SS 1033333 - WST ECC Replacement Jumper Harness Installation.

WST ECC Replacement Jumper Harness Installation

WST 4700, 4800 and 4900

Discontinued ECC Design

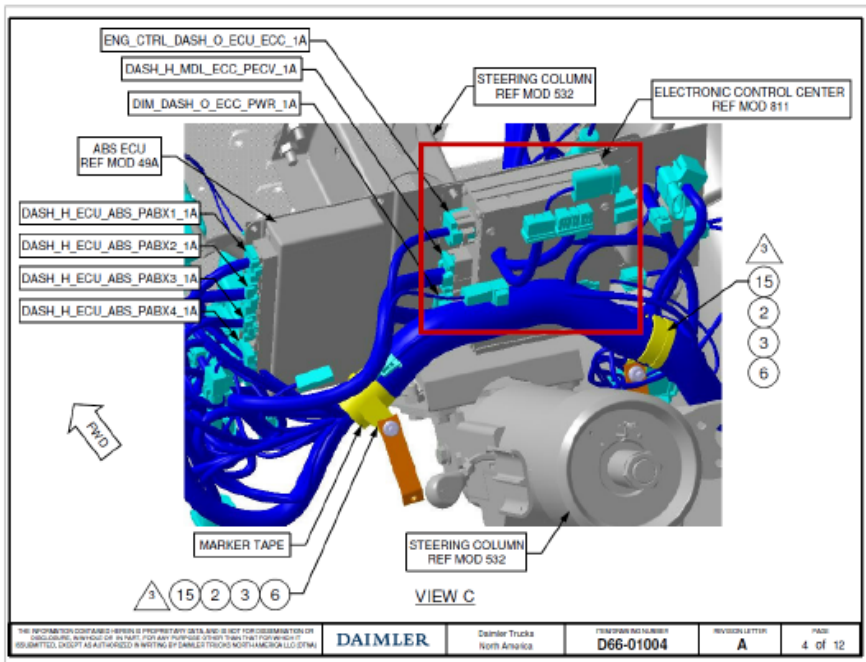
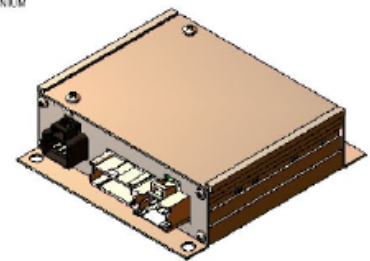
When replacing Older design ECC (shown below) with new design ECC (shown in D66-04983 install), a new jumper harness is required: A06-92186-000

Current ECC Installation (not updated) shown below reflects older version ECC.

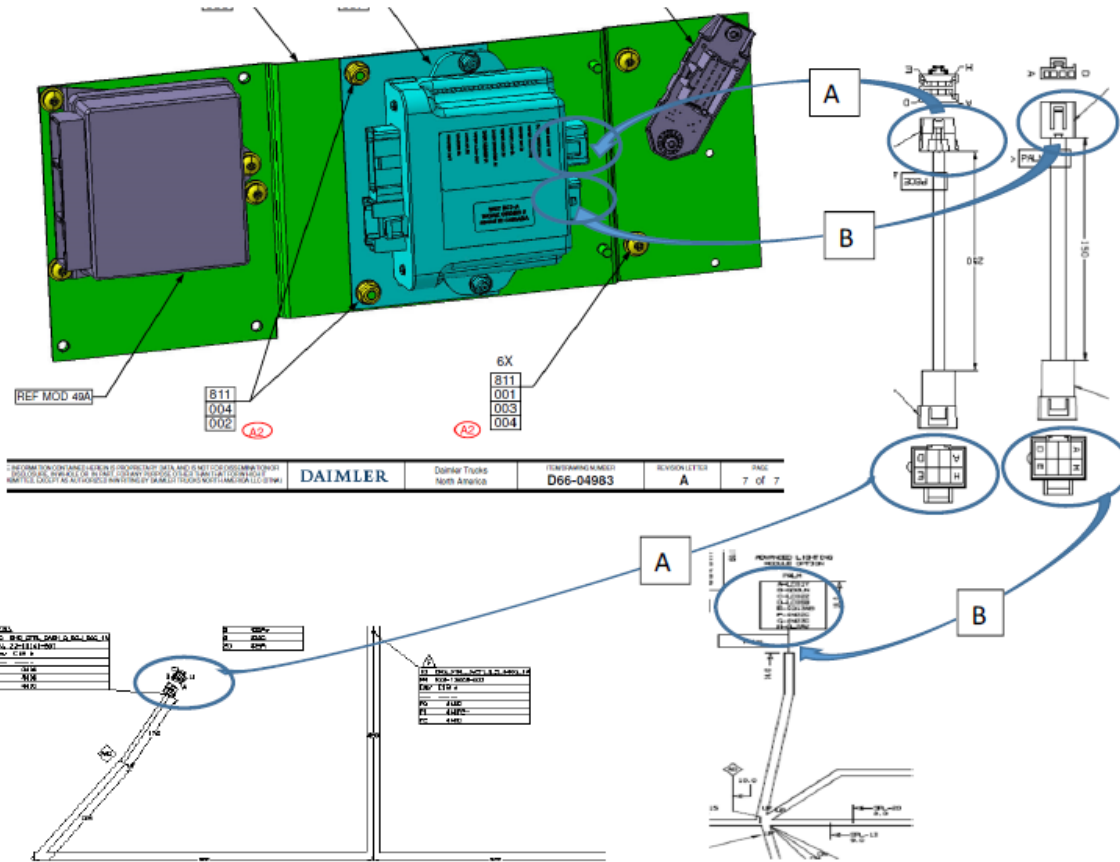
New ECC Version is shown in install below. New ECC Jumper Harness has to be plugged to the 8 Cav Housing from the new ECC as indicated:

Plug 8 Cav Housing from ECC Jumper Harness (A) to 8 Cav Plug from Dash Overlay, Harness Eng-Control (Called on Bill 283). For Sleeper Cabs if equipped with ALM the jumper harness A06-92184-000 is required and is plugged to the Main Cab Dash Harness (B) 4 Cav Connector to the new ECC 4 Cav connector as shown.
